Re: Rapiscan AIT System Radiation Survey Reporting

Fluke	Secure 1000 Radiation Emission Measurement	FORM R-0646-1 (Single Pose)
--------------	---	--

R-0646-1 Addendum (Documentation Errors)

Product Name	Secure 1000SP (Single Pose)
Serial Number	S51039002
Radiation Emission Measurement	Radiation Survey Dated: 11/11/2010
RSO Initials

1. In Beam Dose Measurement: Survey Table. 1

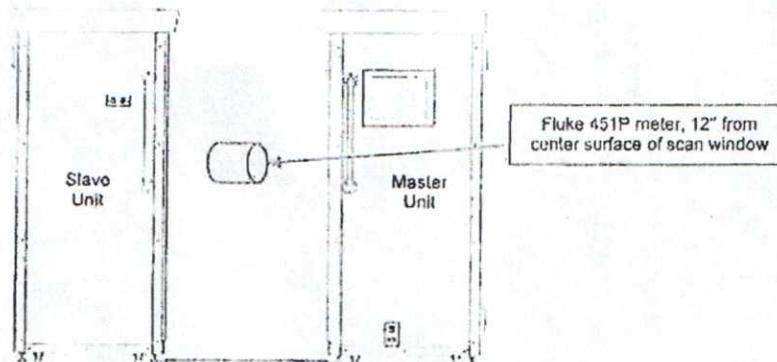
1. TABLE 1: Incorrect presentation of data in Column 3 for Measured Exposure. Indicated values are 14uR and 20uR. Corrected values are 1.4uR and 2.0uR.
2. TABLE 1: Incorrect presentation of data in Column 6 for Effective Dose. Indicated values are 8 uRem and 11 uRem. Corrected values are .81 uRem and 1.15 uRem.

The service technician should attend refresher training.

The corrected data indicates this system was operating within expected parameters. No re-survey is required for this system.
